Amendments to the Drawings

Appl. Ser. No. 10/802,445
Atty. Docket No. 6623-119
Response to final Office Action of November 30, 2005

Fig. 1

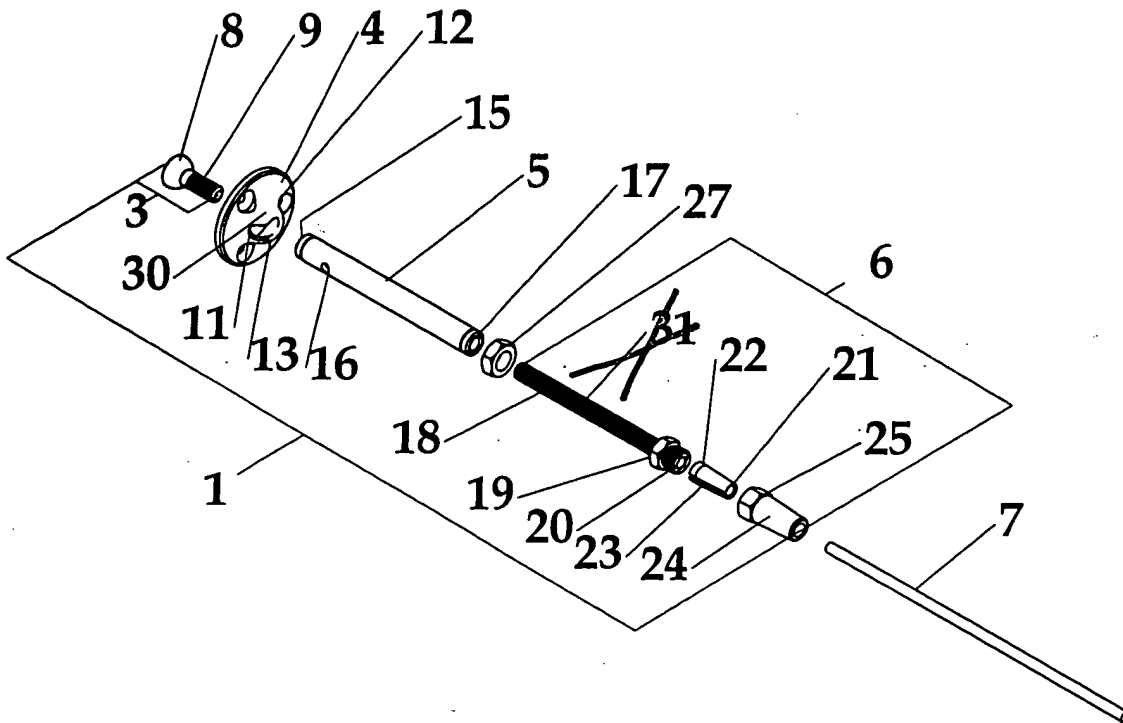
The attached two sheets of drawings (one replacement sheet and one annotated sheet showing changes in red ink) include changes to **Figure 1**. In **Figure 1**, the reference number **31** has been removed as Applicants have become aware that this reference is not referred to in the specification and was made inadvertently and without deceptive intent.
